BCA ASSESSMENT REPORT

**Stockland Ingleburn Logistics Park
35-47 Stennett Road, Ingleburn
Warehouses 5, 6 & 7 (Stage 3)**

**Prepared For:
Stockland**

Date: 27 October 2021

Figure 1 – Warehouse 5 Perimeter Vehicular Access

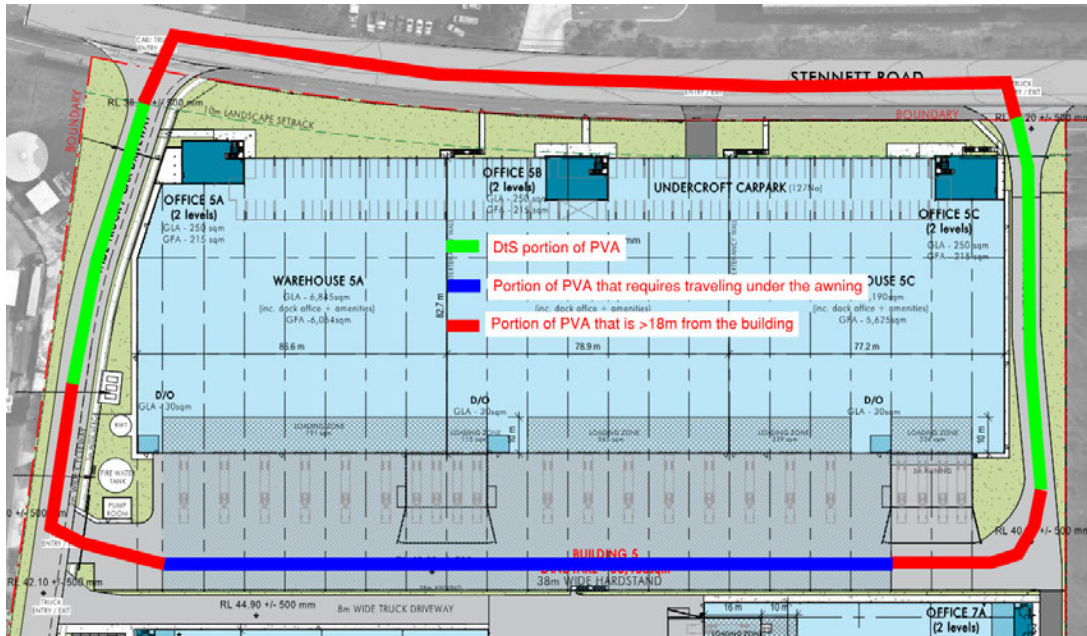
Comments: The proposed buildings do not comply with the provisions of C2.4 and thus the following non-compliance issues are required to be addressed as a Performance Solution by the Fire Engineer to demonstrate compliance with Performance Requirement CP9:

- + Perimeter Vehicular Access is greater than 18m from the northern side of the building and the south-east and south-west corners.
- + Perimeter Vehicular Access requires travelling under the awning on the southern side of the building.

Figure 2 – Warehouse 6 Perimeter Vehicular Access per BCA C2.4.

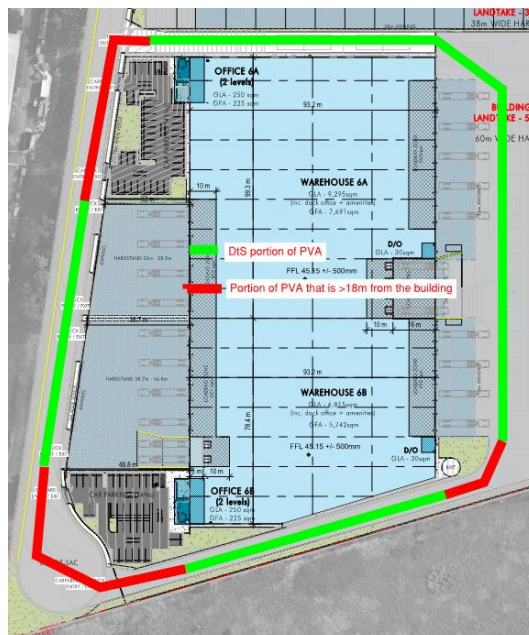
- + Perimeter Vehicular Access is greater than 18m from the building in the north-west, south-east and south-west corners.

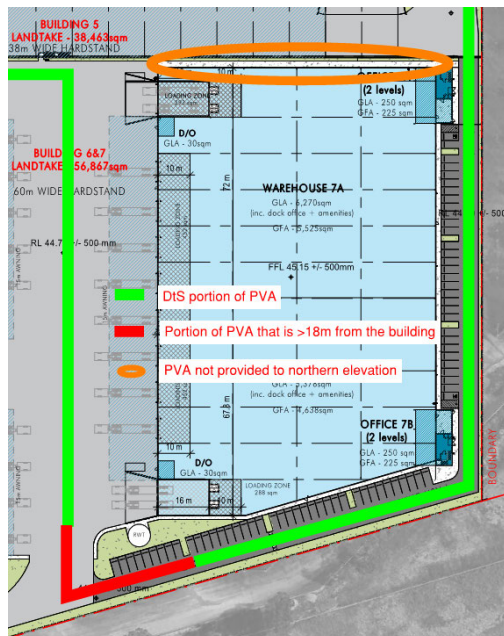
- + Perimeter Vehicular Access is greater than 18m from the building in the south-west corner;
- + Perimeter Vehicular Access is not provided along the northern side of the building.

Typical Office 5B & 5C

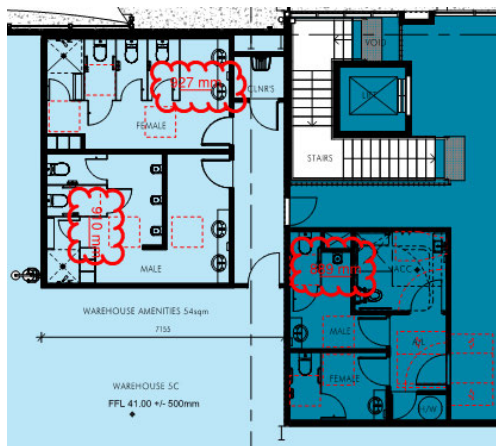
In addition to the above, it is to be noted that all exit paths are required to have a minimum clear width of 1m and height of 2m and 1980mm through doorway openings per D1.6(a). Particular attention is drawn to the banks of sanitary facilities within each tenancy, where 1m unobstructed width is required throughout all areas (with the exception of the cubicles). See below typical examples of areas which are non-compliant (noting there are non-compliances in Warehouses 5B, 5C, 6A, 6B & 7A):
